MEMORANDUM

To:	Wabasha City Council
Cc:	Caroline Gregerson Wabasha City Administrator
From:	David L. Betts, PE Project Manager
Date:	October 29, 2025
Re:	City of Wabasha TH 60 Realignment SP 079-080-001 & SP 7910-16 Project Concepts Review and Preferred Alternate Selection

CITY OF WABASHA
TRUNK HIGHWAY 60 REALIGNMENT
LAYOUT B

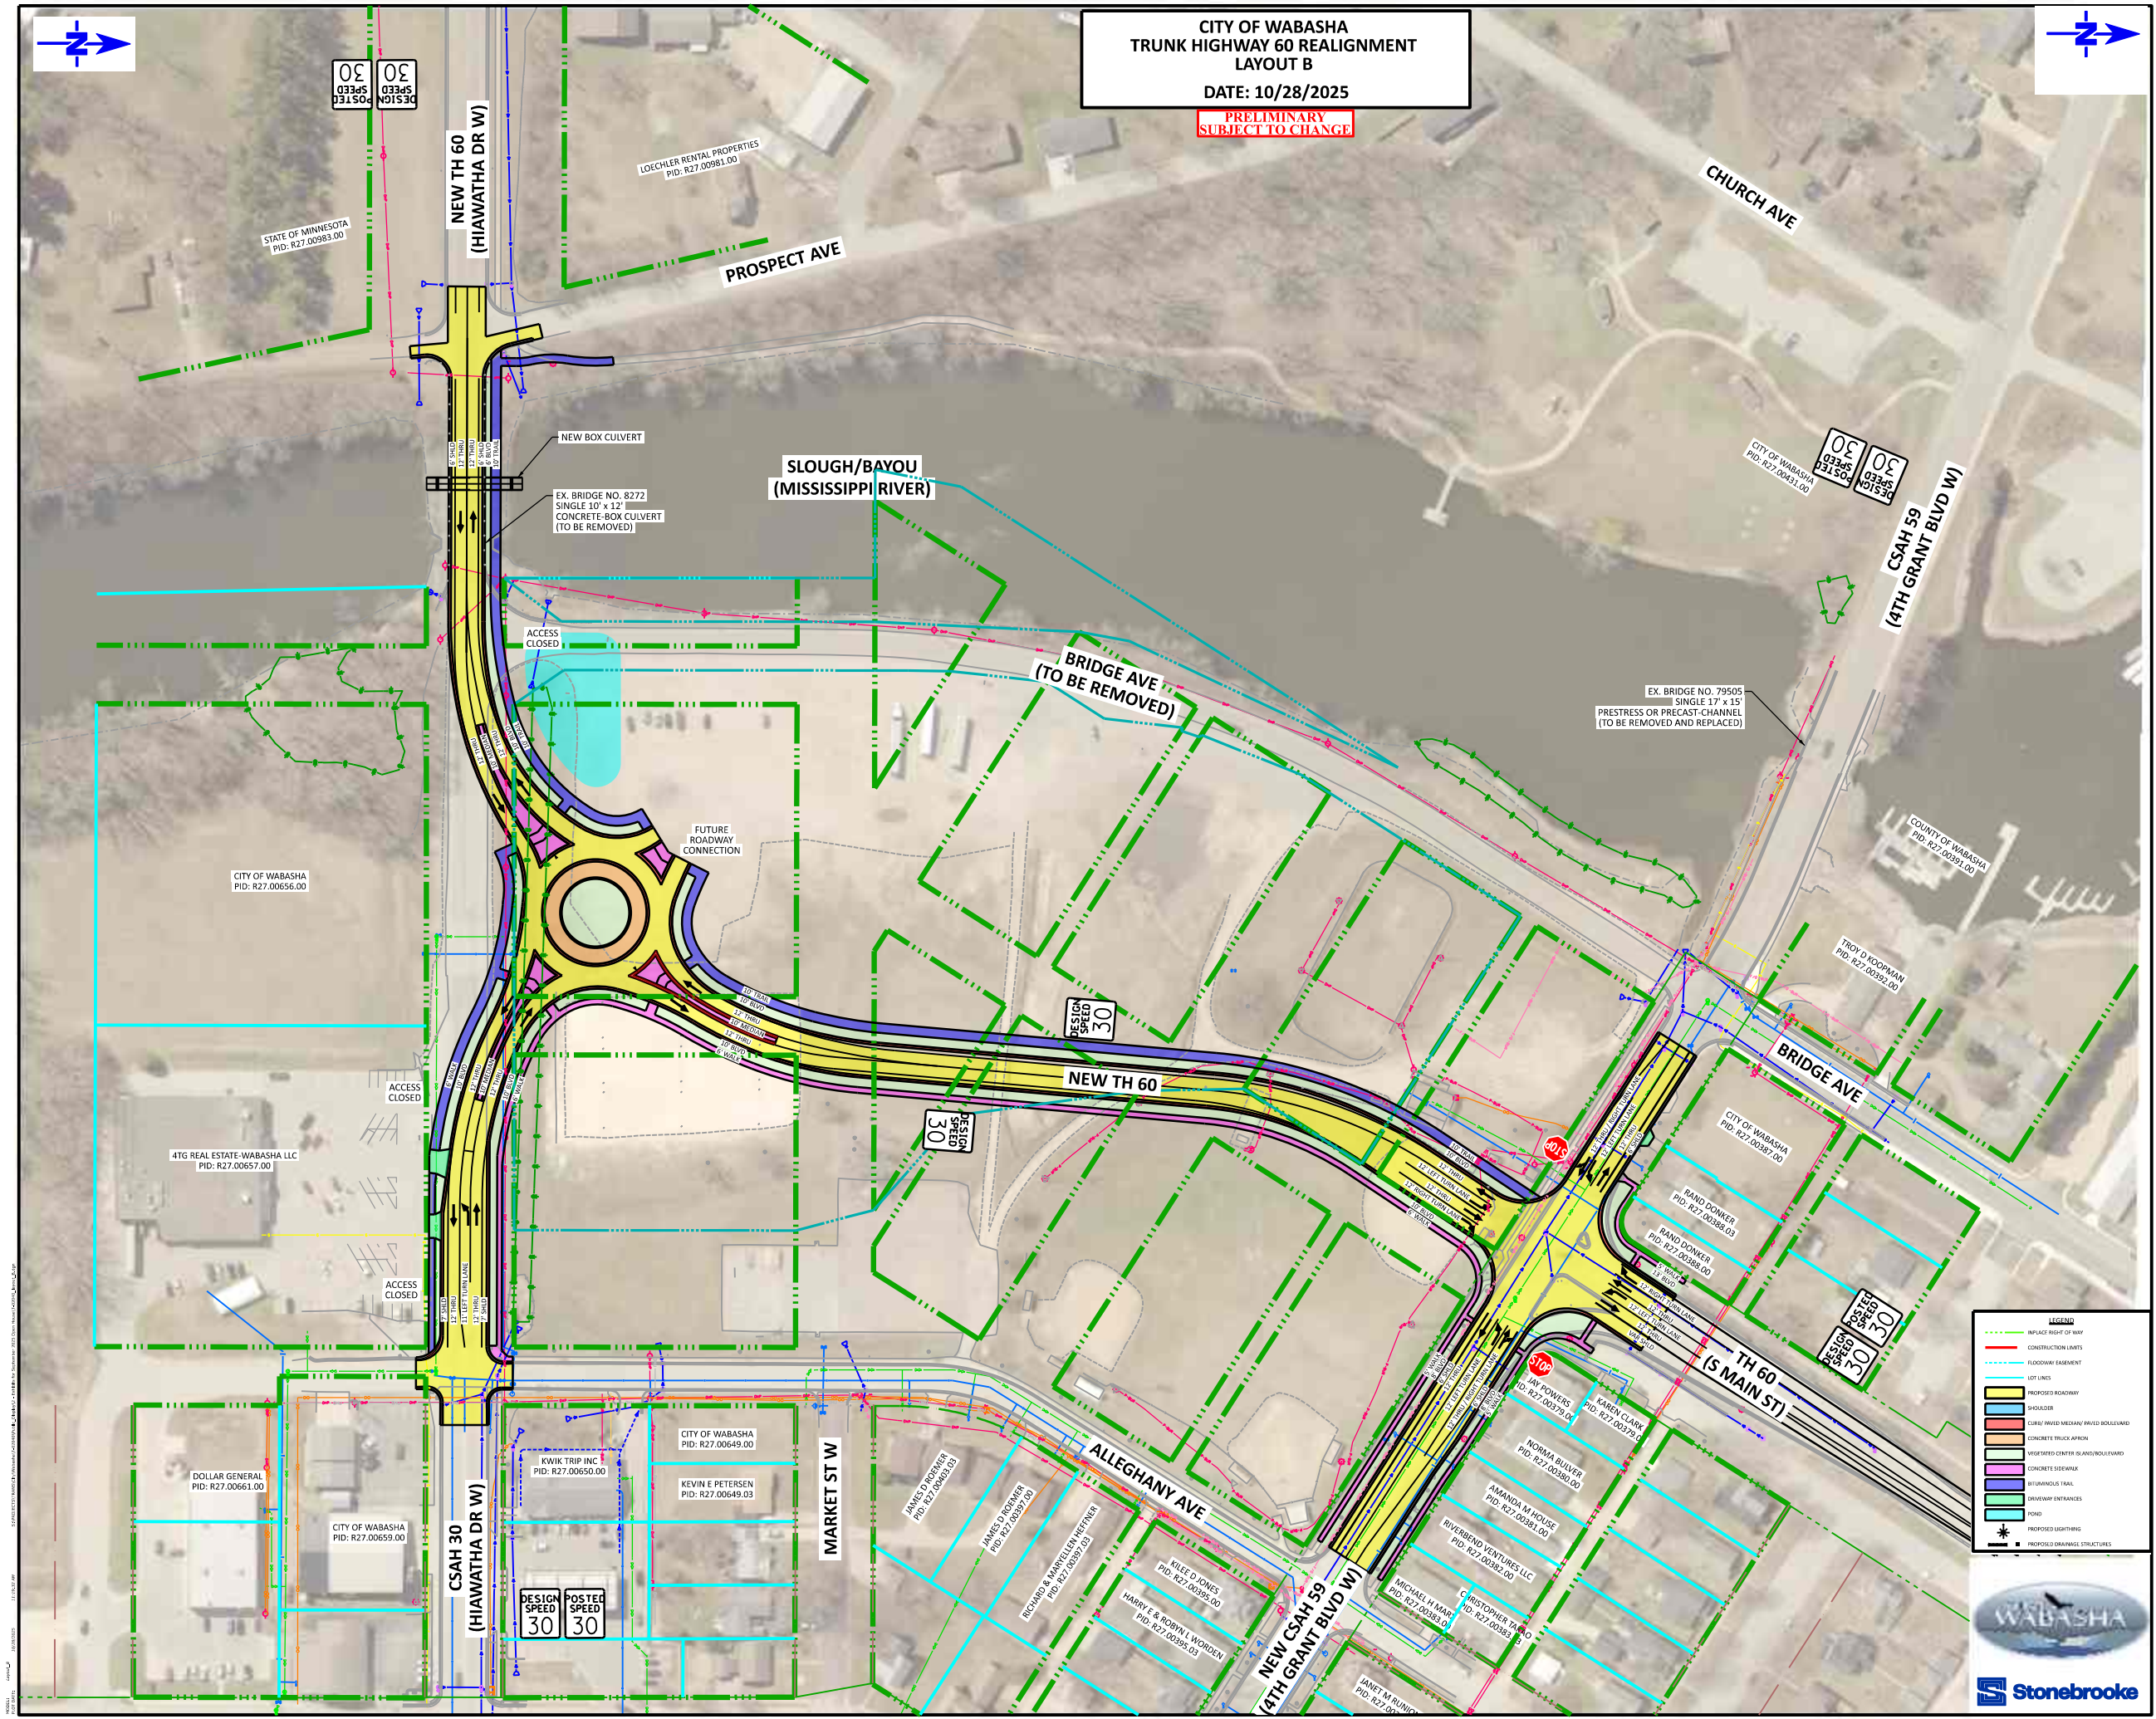
Layout B is similar to Layout A, featuring a stop-controlled intersection at 4th Grant Blvd, but a roundabout at Hiawatha Drive. This layout is recommended to be eliminated due to safety concerns at the intersection of 4th Grant Boulevard and TH 60.

- 1) Eliminate Layout A and Layout B from consideration due to intersection safety and operations issues.
- 2) Select Layout C2 as the preferred alternative, with any conditions or revisions.
- 3) Motion to incorporate suggestions by County, City engineering staff, and City Planner into the final designs and project as permitted.

CITY OF WABASHA
TRUNK HIGHWAY 60 RE-ALIGNMENT PROJECT
LAYOUT C1
DATE: 10/28/2025

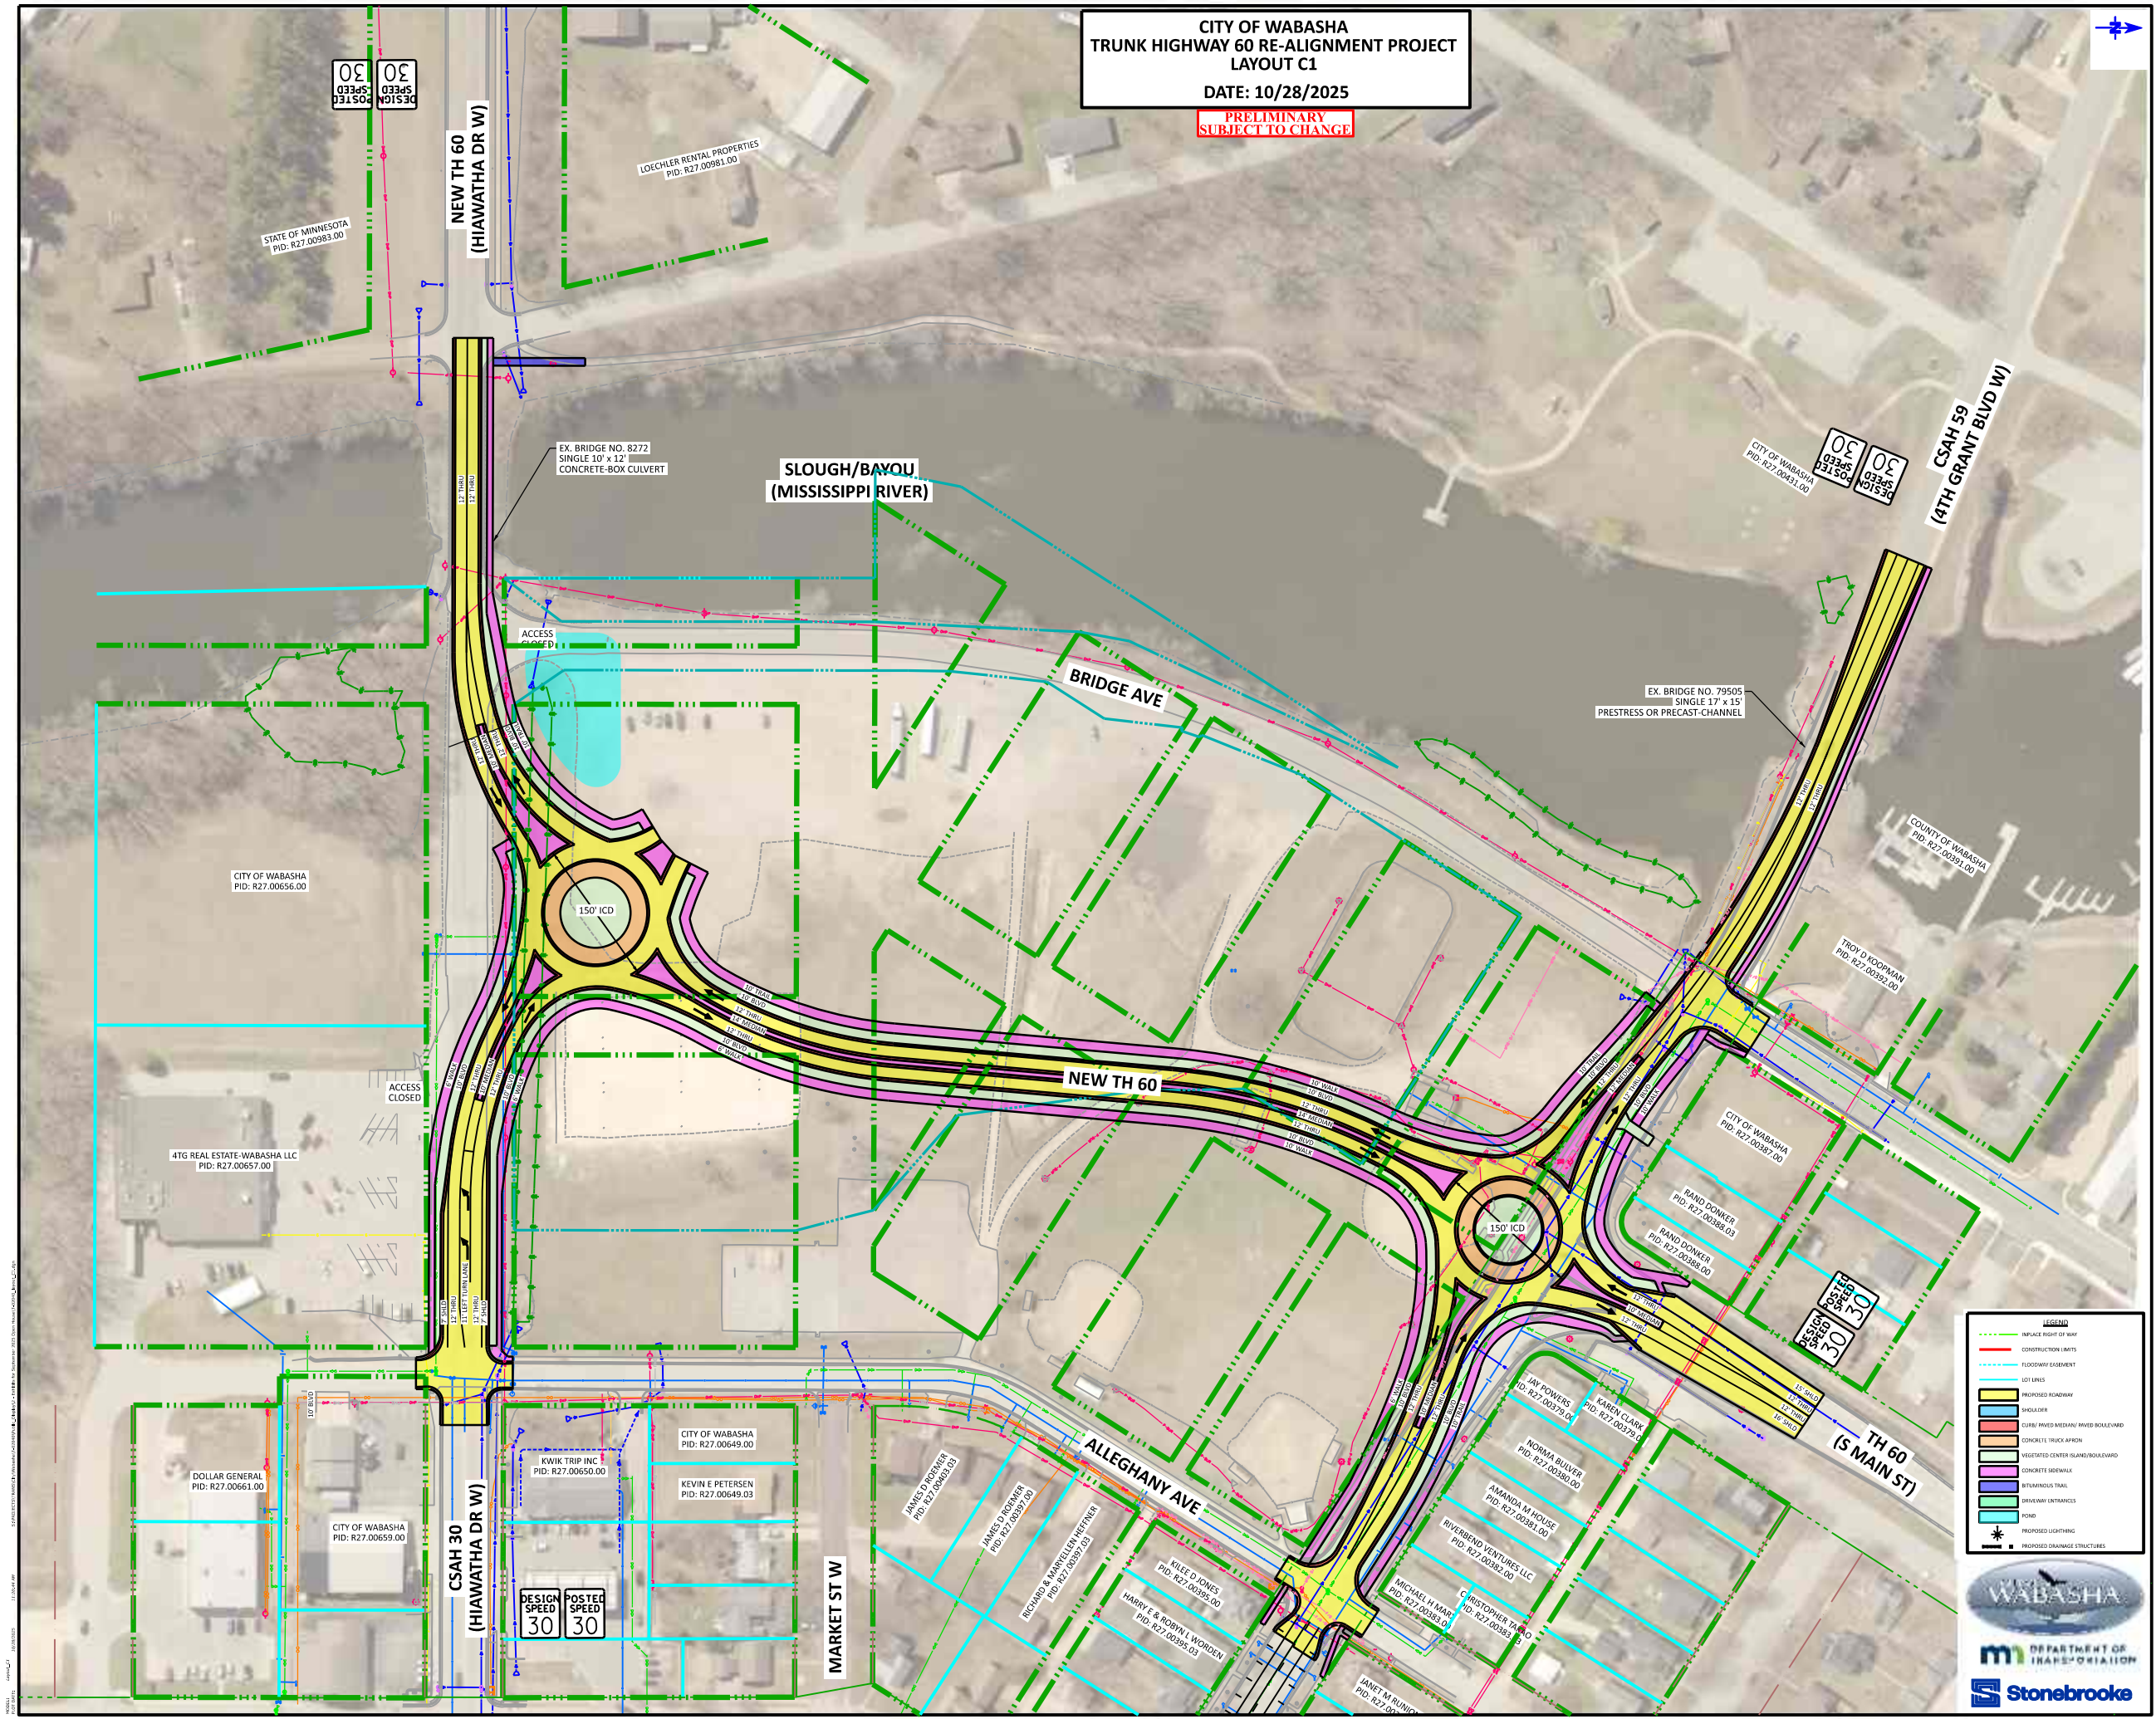
Layout C1 features a roundabout at both 4th Grant Boulevard and Hiawatha Drive, with the Hiawatha Drive roundabout situated within the existing park property on a similar alignment to Layouts A & B. This option has an opening for a roadway into the former park, west of the new TH 60, from the Hiawatha Drive roundabout. This option features a center median between the two roundabouts with right-in/right-out access mid-block.

- On Layouts C1 and C2, there is also no shoulder shown on Hiawatha Dr that would transition to a bike ramp to a trail/sidewalk from either direction. Except in the roundabout and roundabout medians, a shoulder on Hiawatha and Grant is preferred by the County. Truck traffic (and especially with snowbanks) would seem to make a traffic-lanes-only road on this freight corridor(s) narrow.

For the existing Hwy 60 Intersection, both the C1 and C2 layouts appear not to be significantly different from each other or from previous reviews. Therefore, as previously commented:

- MnDOT feels that the ICDs could be reduced to allow for the potential reduction in any R/W impacts at the intersection, particularly to the properties on 4th Grant Blvd.
- MnDOT has concerns about the minimum entry widths and will review further at the time that geometric data (PHI angles, entry widths, curve data) are provided.
- MnDOT Guidance requires a Level 1 layout with GDSU Review for the Existing Hwy 60 Intersection for the roundabout design.
